Re: 339 West Gorham Street: Oliv Madison

Attached is a minor amendment packet for the Oliv Madison Project. These changes address some program elements (expanded amenity), design refinements, and adding solar to the project. The packet illustrates the changes between the Original SIP document and the proposed amendments. The site plan review/building permit set elevations are also included for reference to show what was approved with the building permit.

UDC MINOR REVISIONS

OLIV MADISON 339 W GORHAM STREET

MADISON, WISCONSIN • DECEMBER 19, 2022

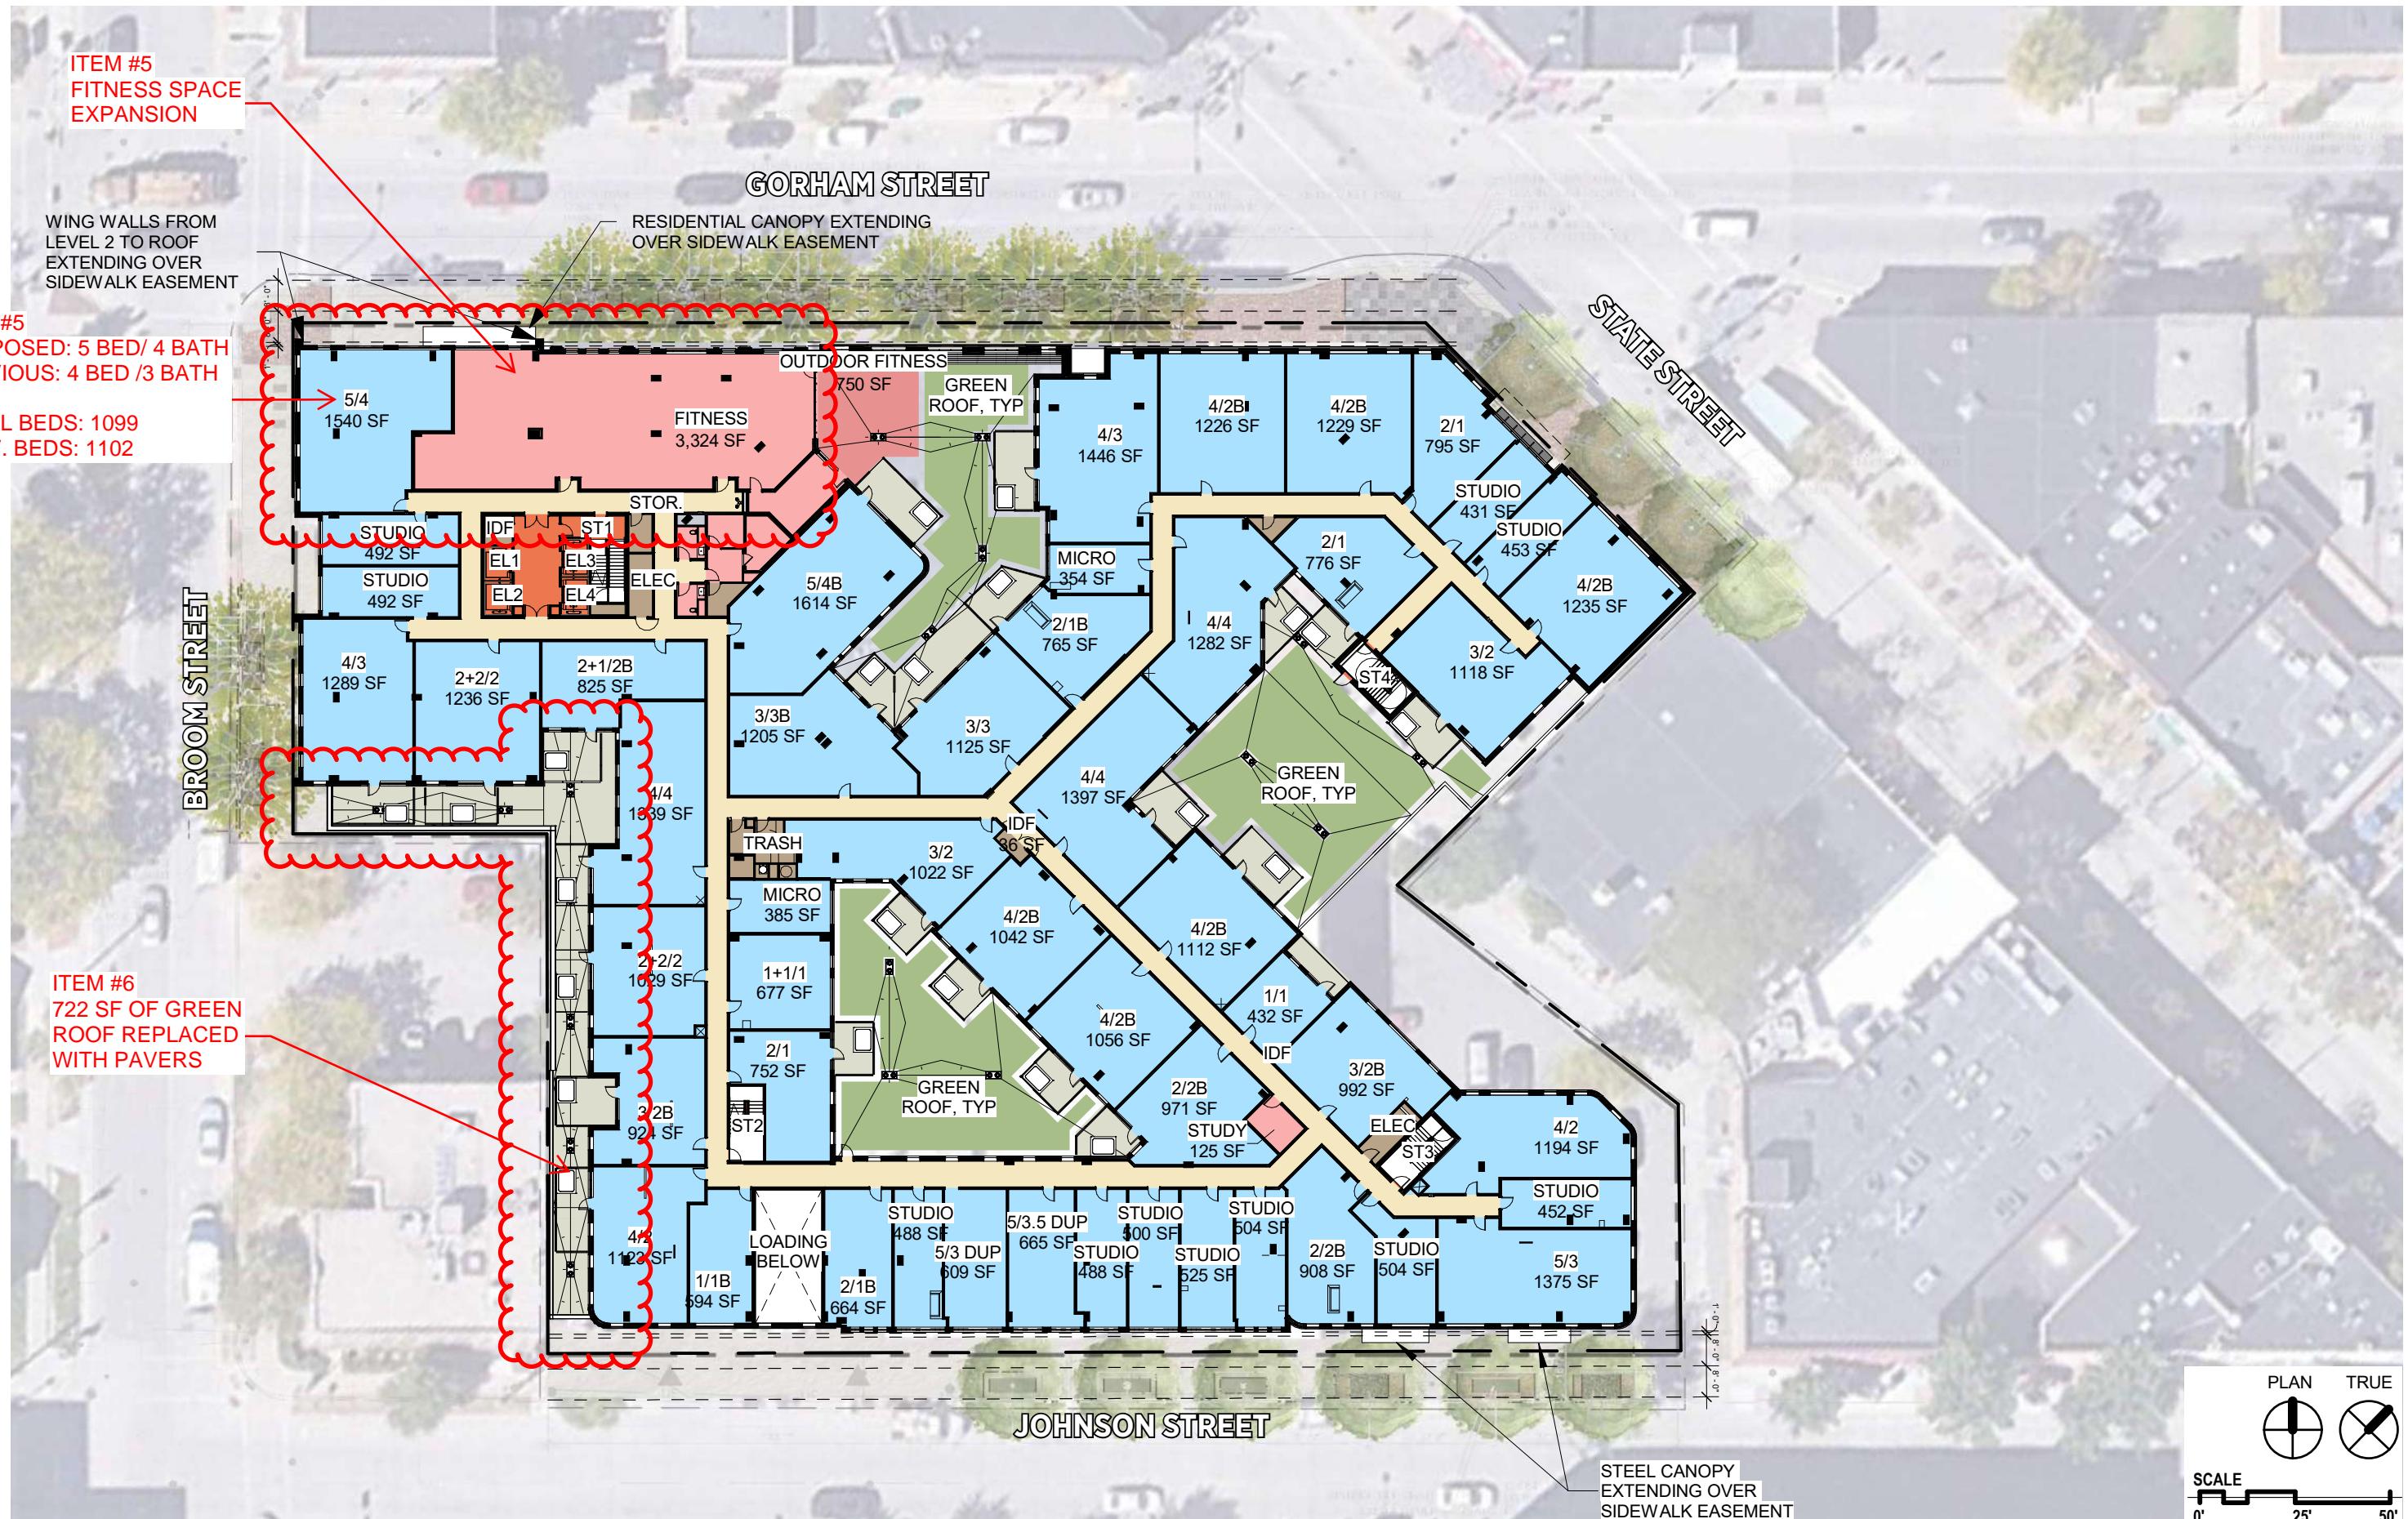
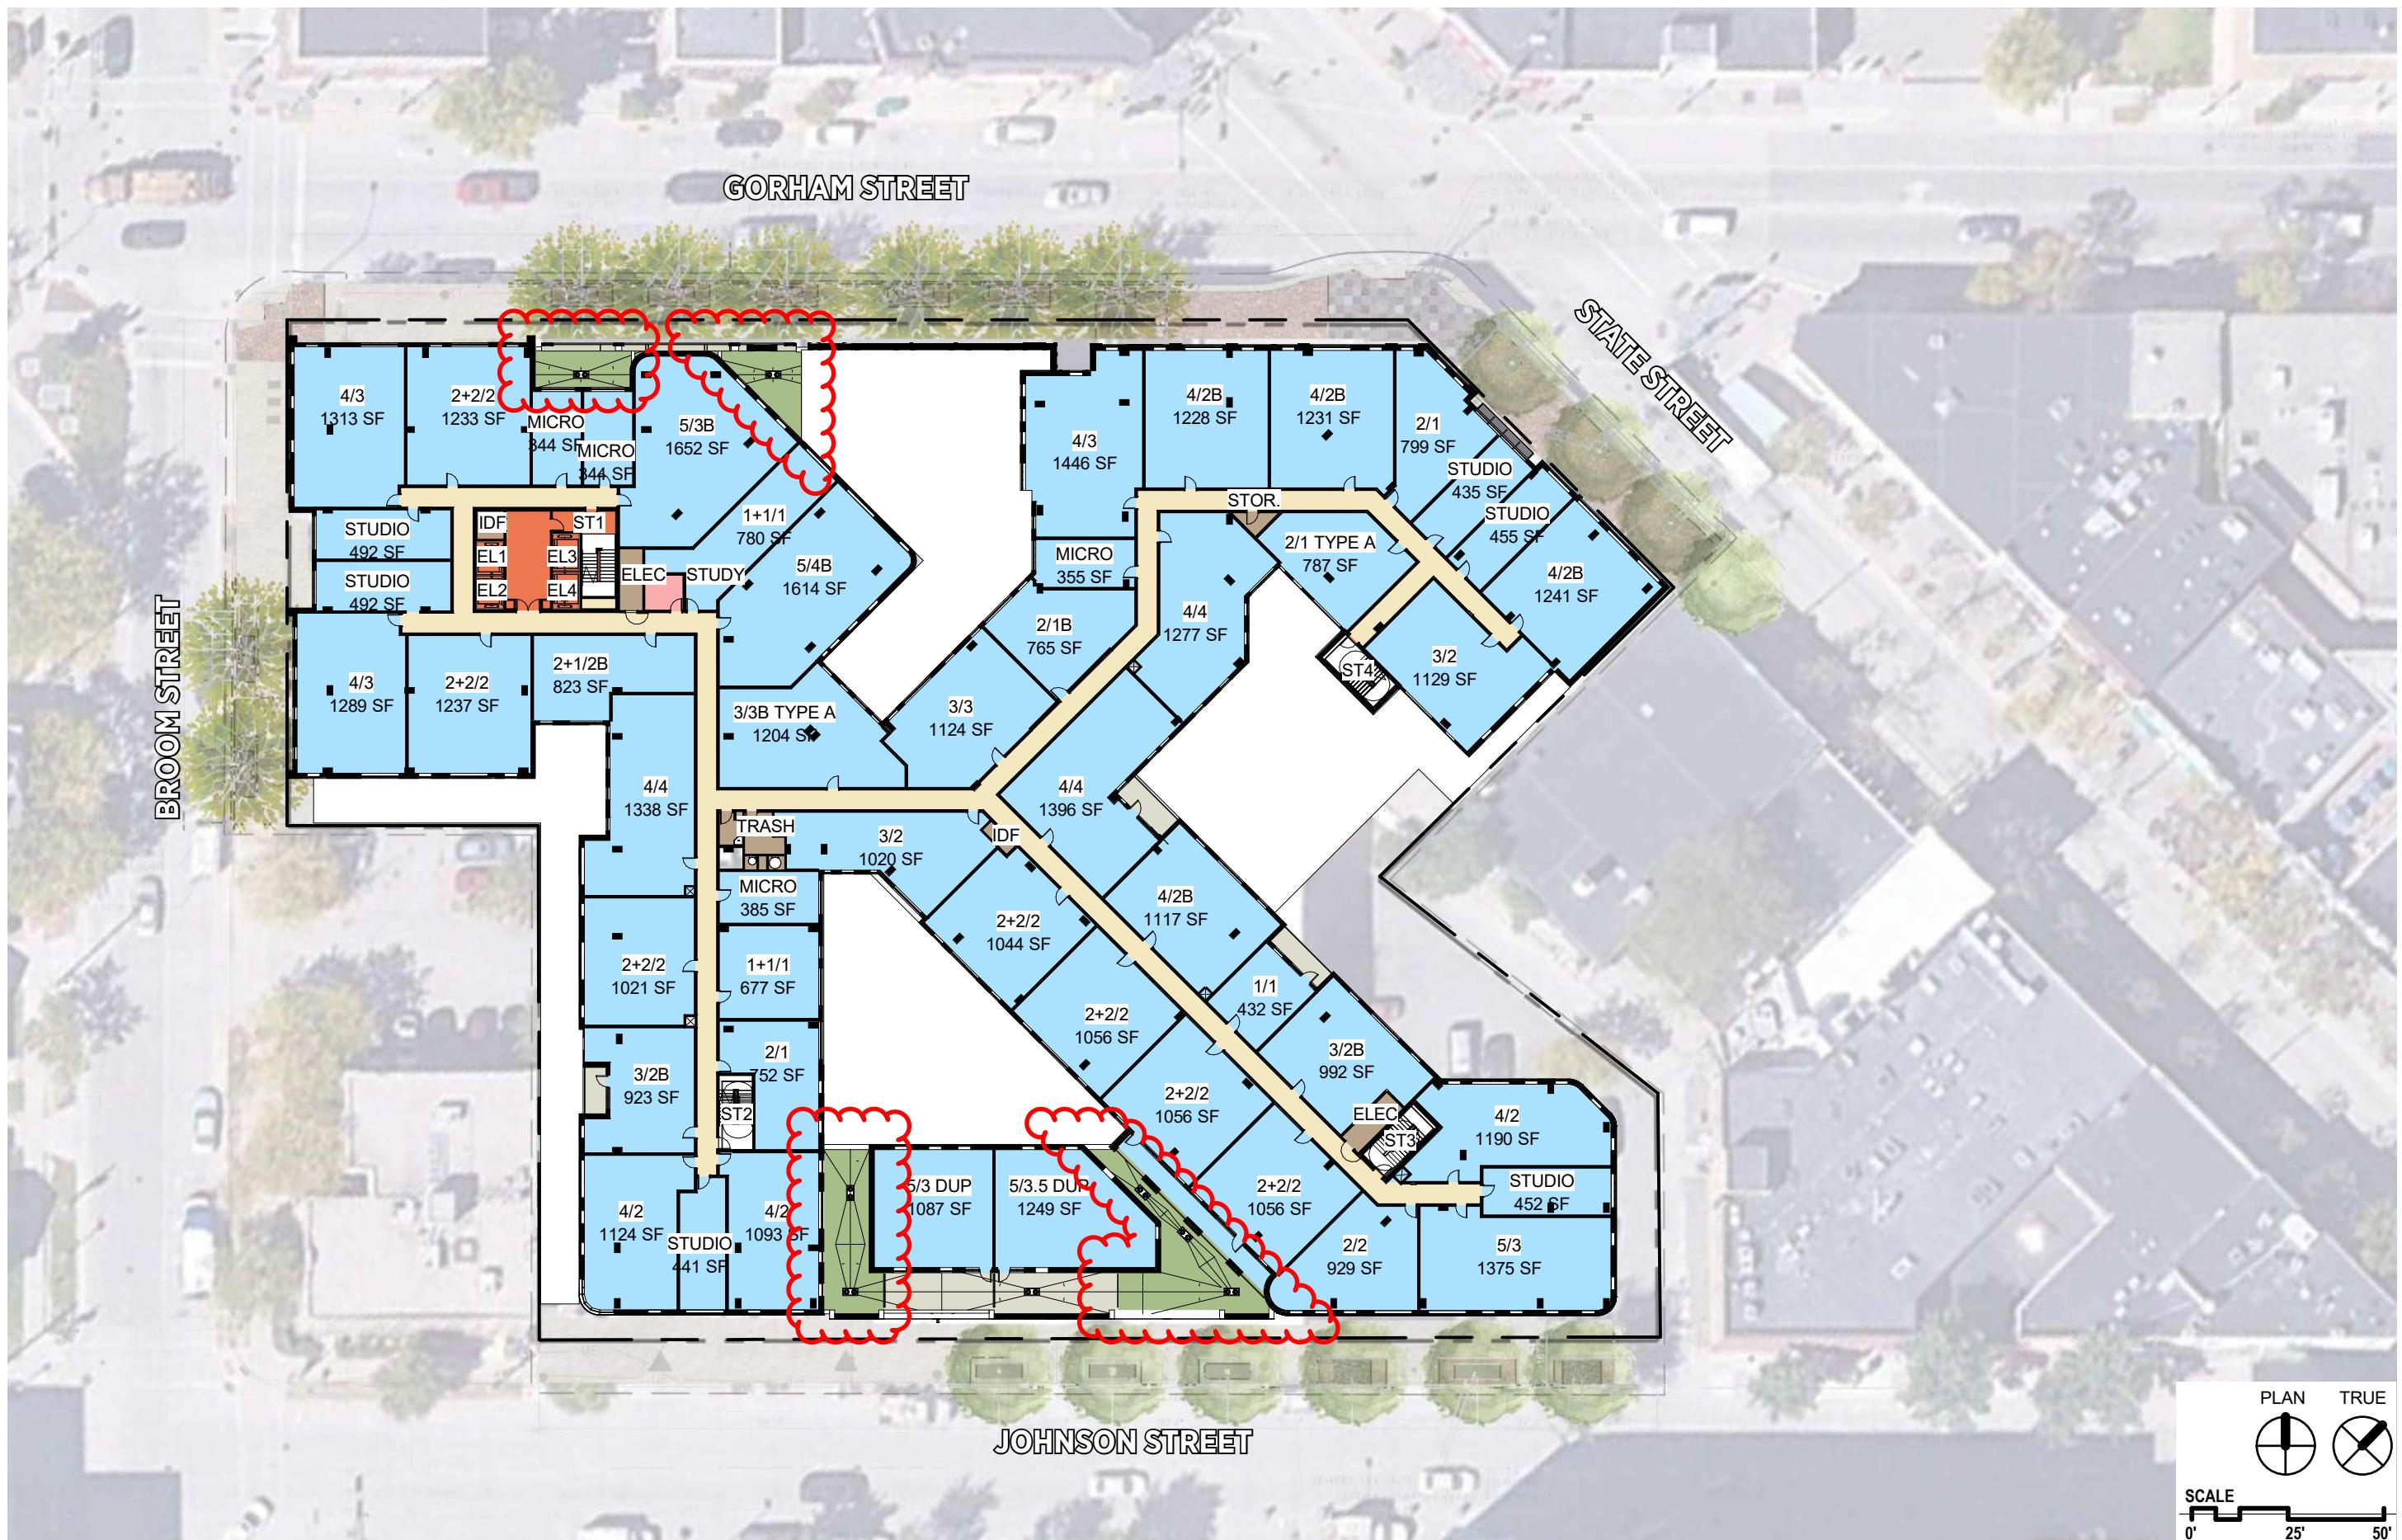
- Item 5. Increased Fitness Room size (A45): Revise 2nd floor to remove one unit, revise adjacent unit, and expand fitness amenity space (net reduction 1 unit and 3 beds).
